ADDENDUM NO. 2

Reference: New Residential Life Building
Weber State University – Ogden, Utah
DFCM Project No. 09191810

Addendum No. Two
for the
Weber State University
New Residential Life Building
DFCM Project No. 09191810
MHTN Project No. 2009566

1 LEVEL 1 FLOOR PLAN - AREA 'A'

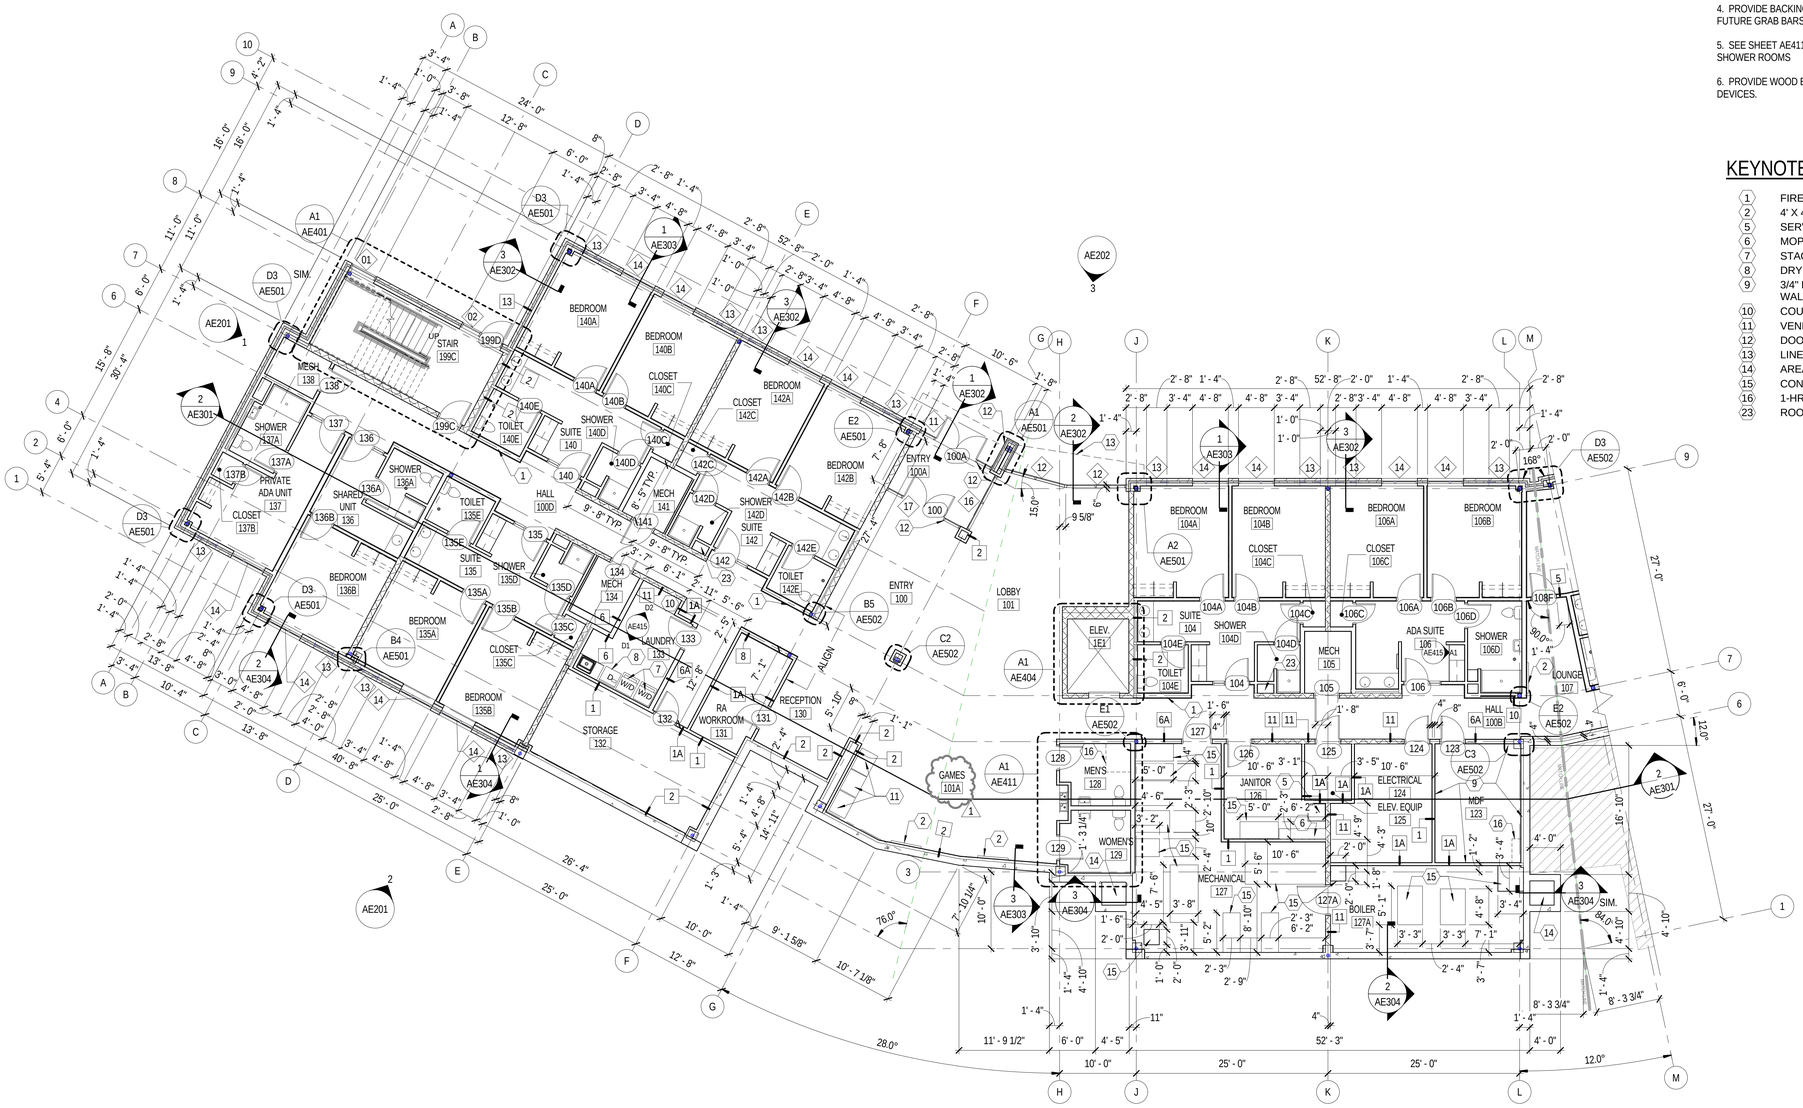
A2.31 Sheet AE101A

A. The Space east of the vending machines is identified as Games 101A. See attached Sheet AE101A.

2 WALL SECTION
SCALE: 3/4" = 1'-0"

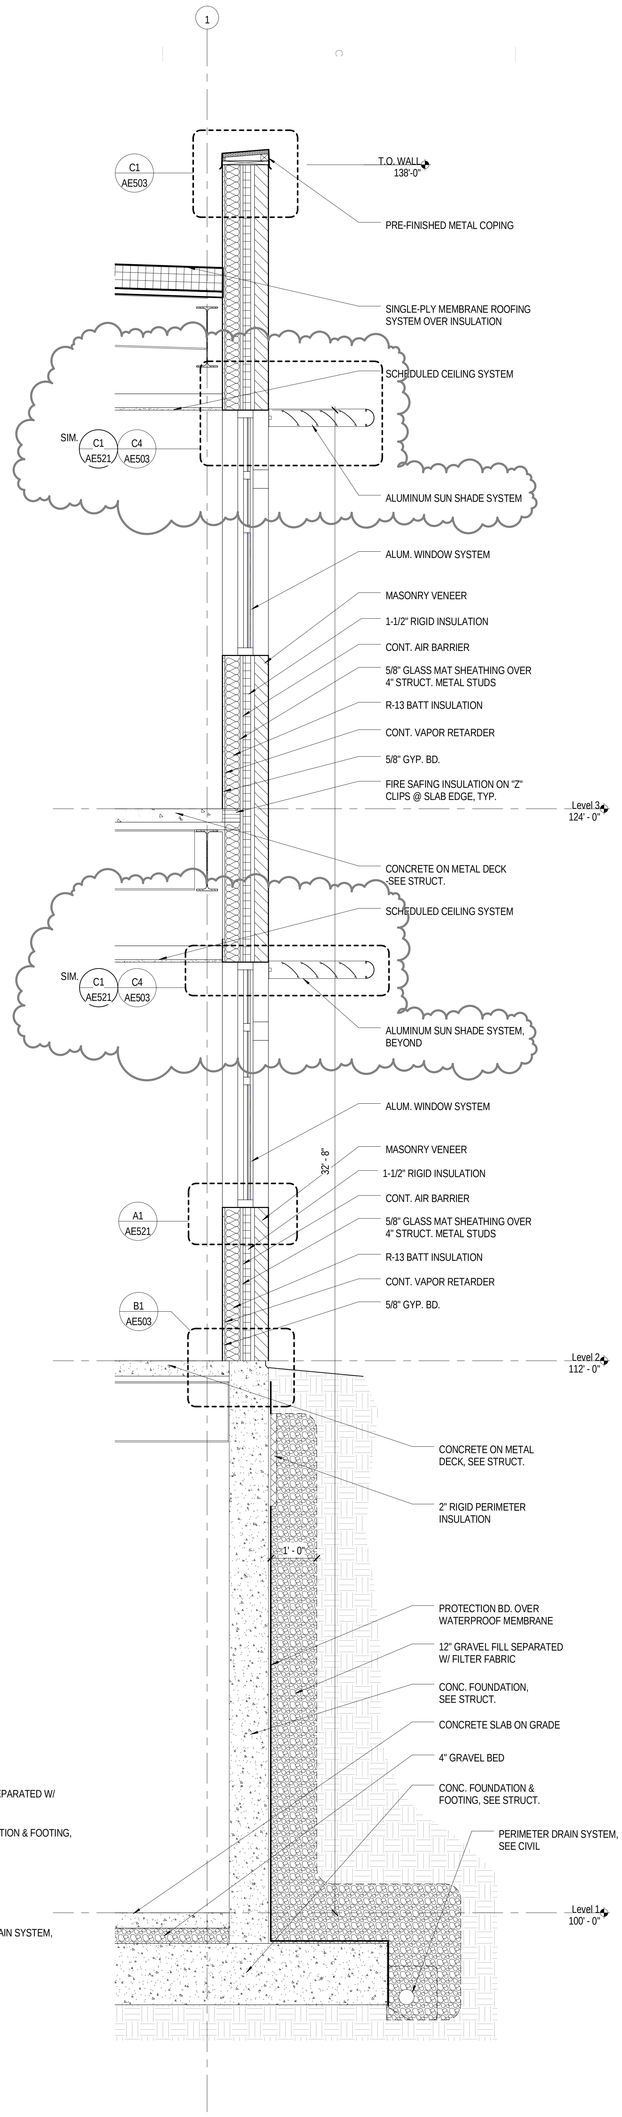
A2.33 Sheet AE304

A. Wall Section 2/AE304 has been revised to show the aluminum sun shade system at the head of the window system. See attached Sheet AE304.

C4 DETAIL

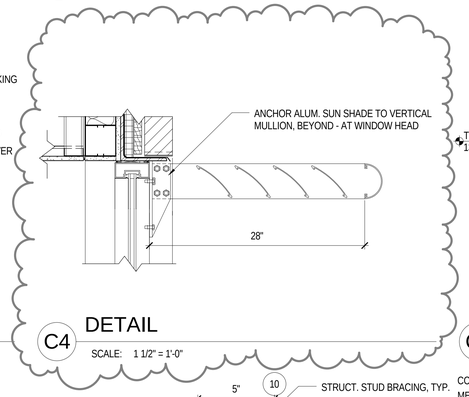
A2.34 Sheet AE503

A. Detail C4/AE503 has been revised to show the aluminum sun shade system at the head of the window system. See attached Sheet AE503.

C5 DETAIL

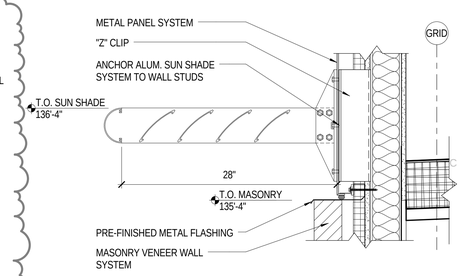
A2.5 **Question #4:** Per C5/AE503, are the metal wall panels structurally able to support the sun shades?

Answer: The support for the sun shades is behind the metal wall panel.

A1 DETAIL

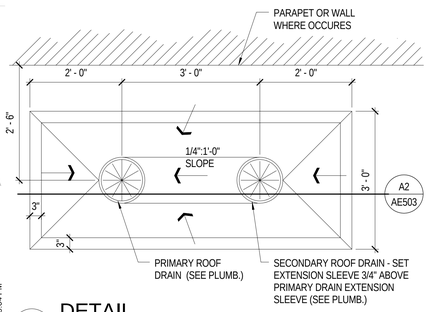
A2.7 **Question #6:** Per section 074243, 2.6, A, this section calls for a dry-joint system. Detail AE-501/A1, appears to detail a wet-joint system. Please clarify.

Answer: The sealant was inadvertently deleted from the details and should be included.

TYPICAL MASONRY / JAMB REINFORCING SCHEDULE

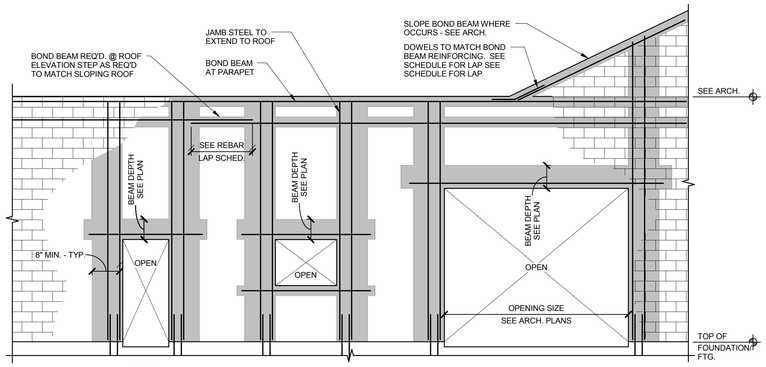
Sheet SG601
-The masonry jamb schedule has been revised. Please see the attached revised sheet.

ADD ALTERNATE #1

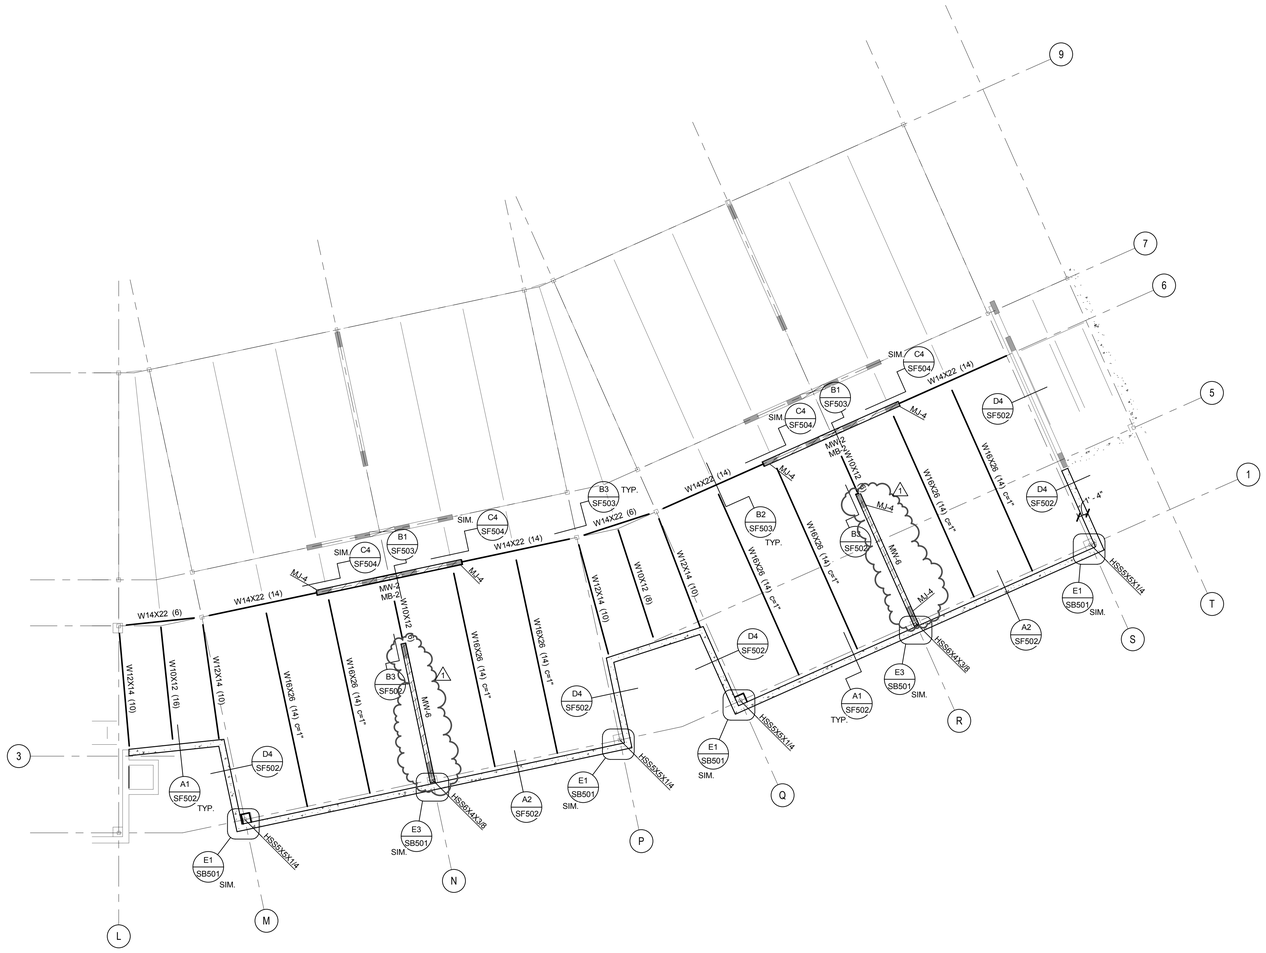
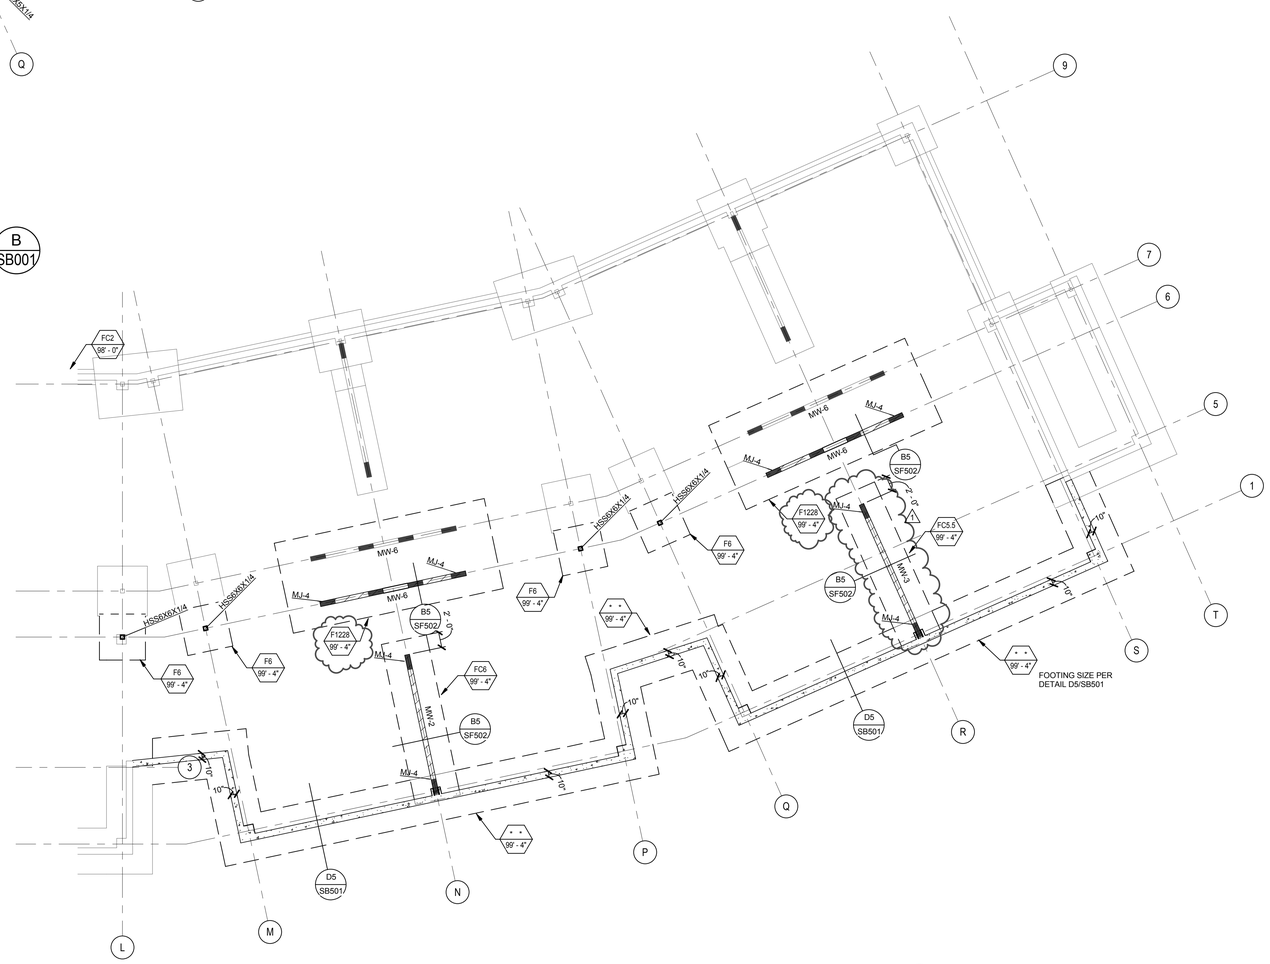
Sheet SB001
-Masonry jamb callouts have been revised. Please see the attached revised sheet.

FOOTING & FOUNDATION PLAN - AREA 'A'

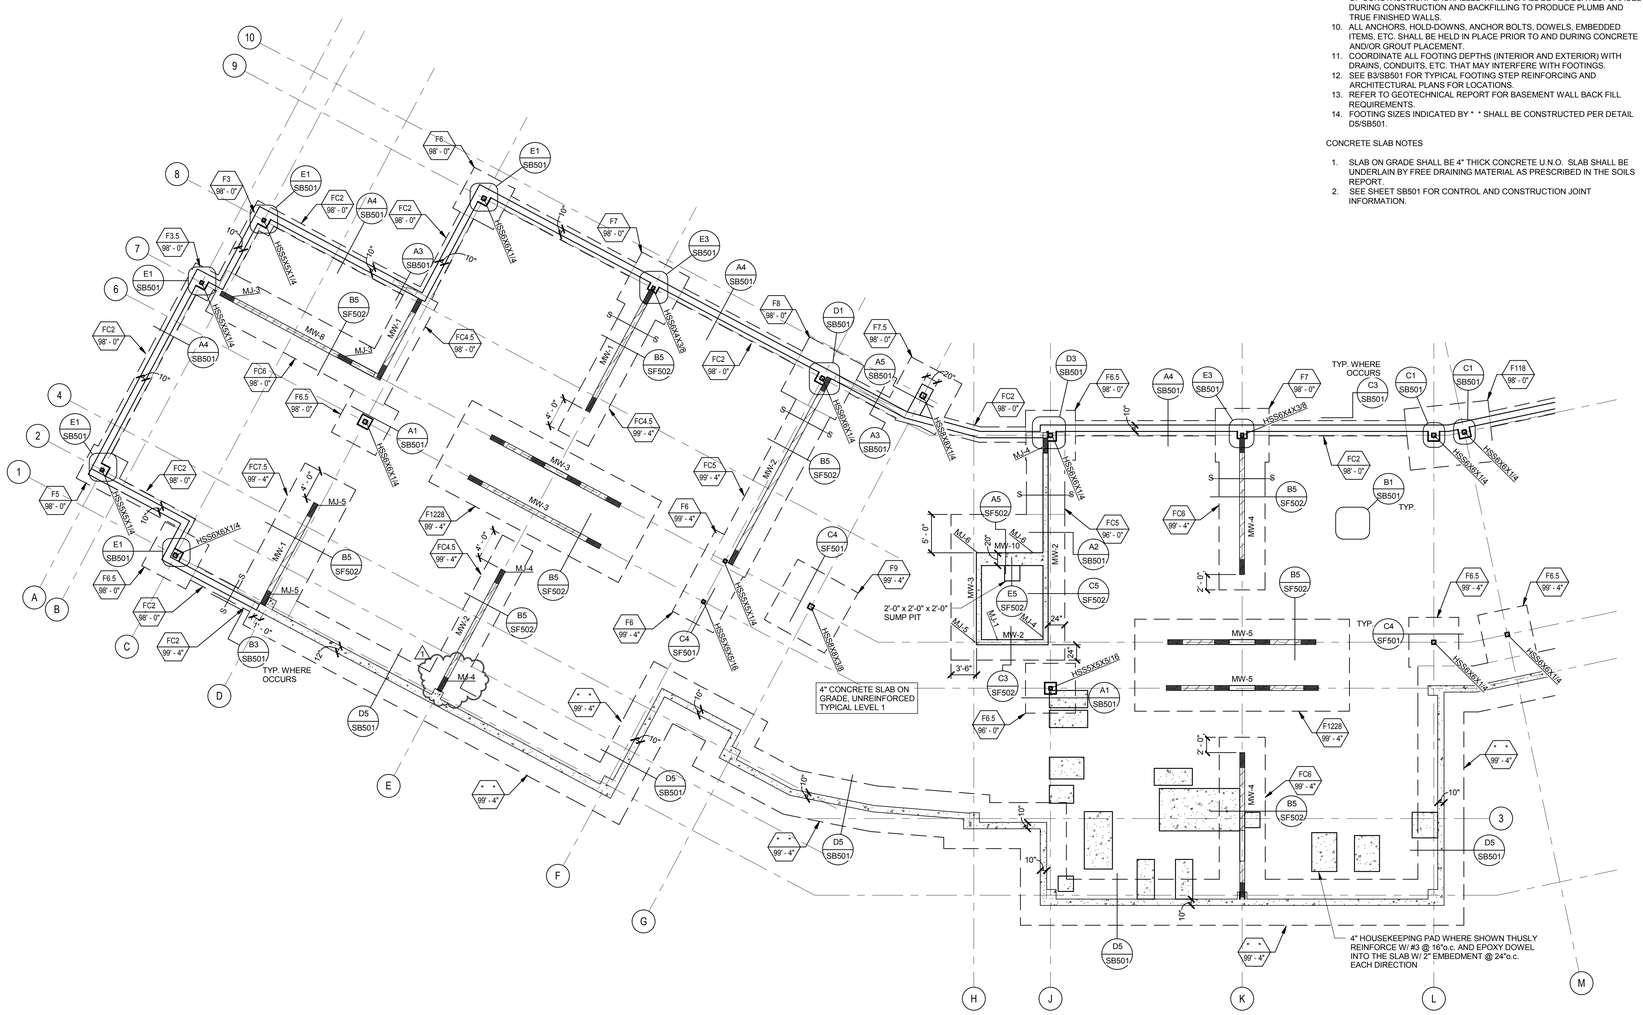
Sheet SB101A
-Masonry jamb callouts have been revised. Please see the attached revised sheet.

SECOND FLOOR FRAMING PLAN - AREA 'A'

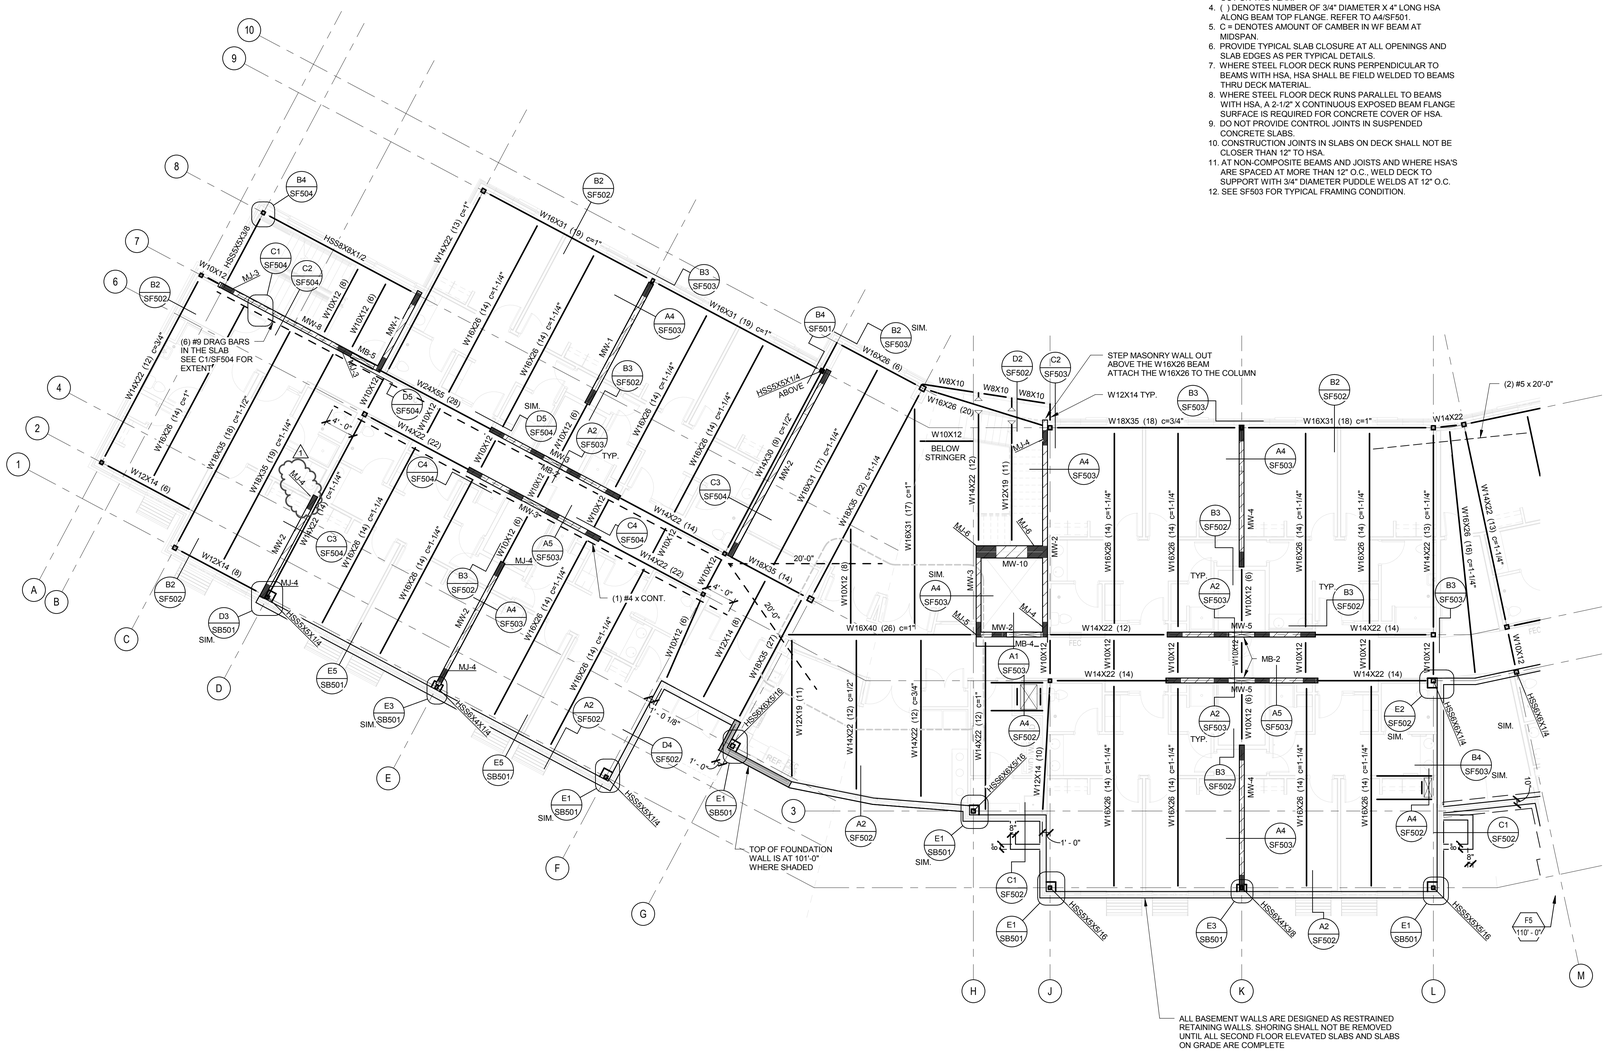
Sheet SF102A
-A masonry jamb callout has been revised. Please see the attached revised sheet.

SECOND FLOOR FRAMING PLAN - AREA 'B'

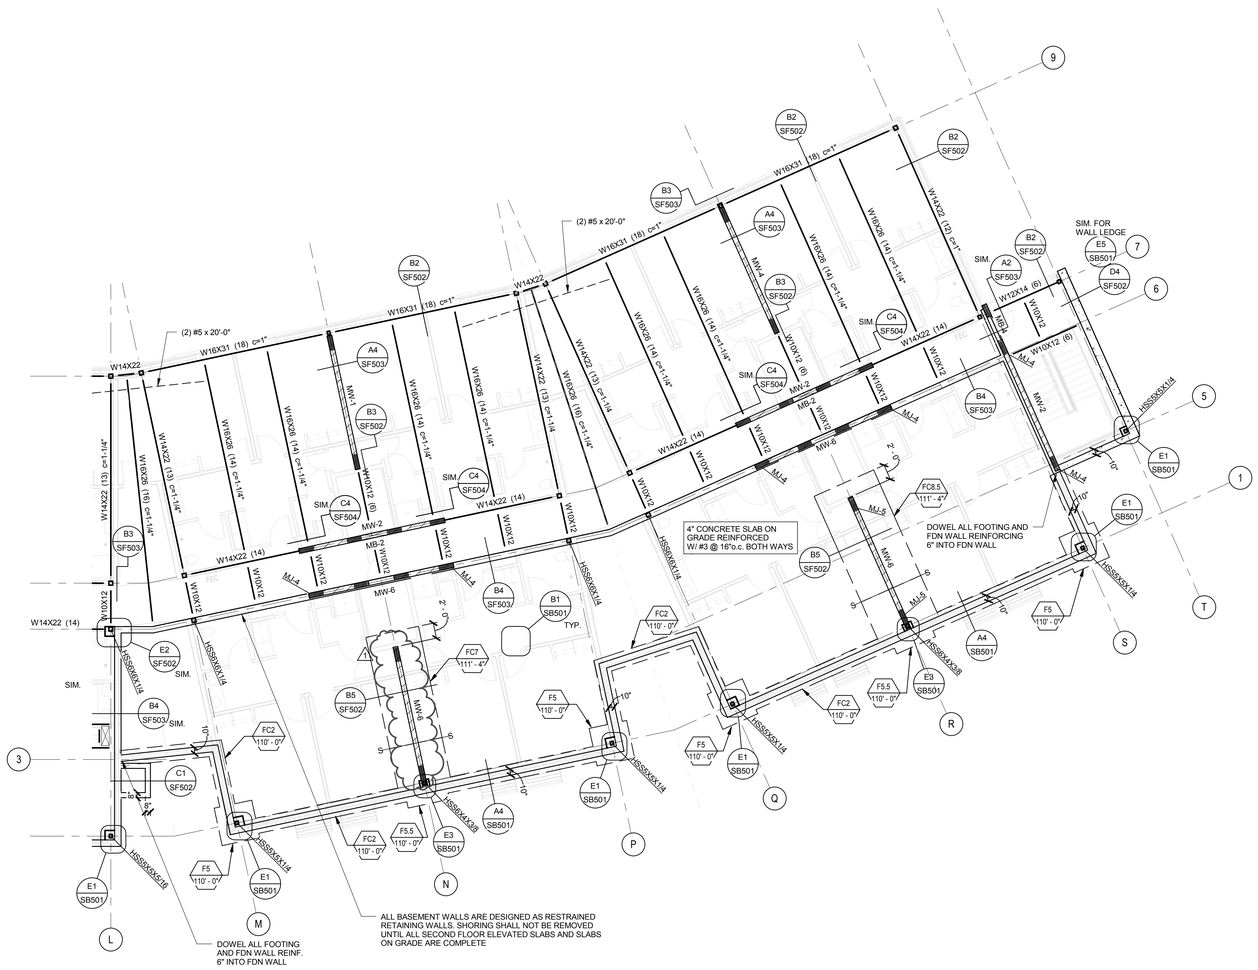
Sheet SF102B
-Masonry jamb callouts have been revised. Please see the attached revised sheet.
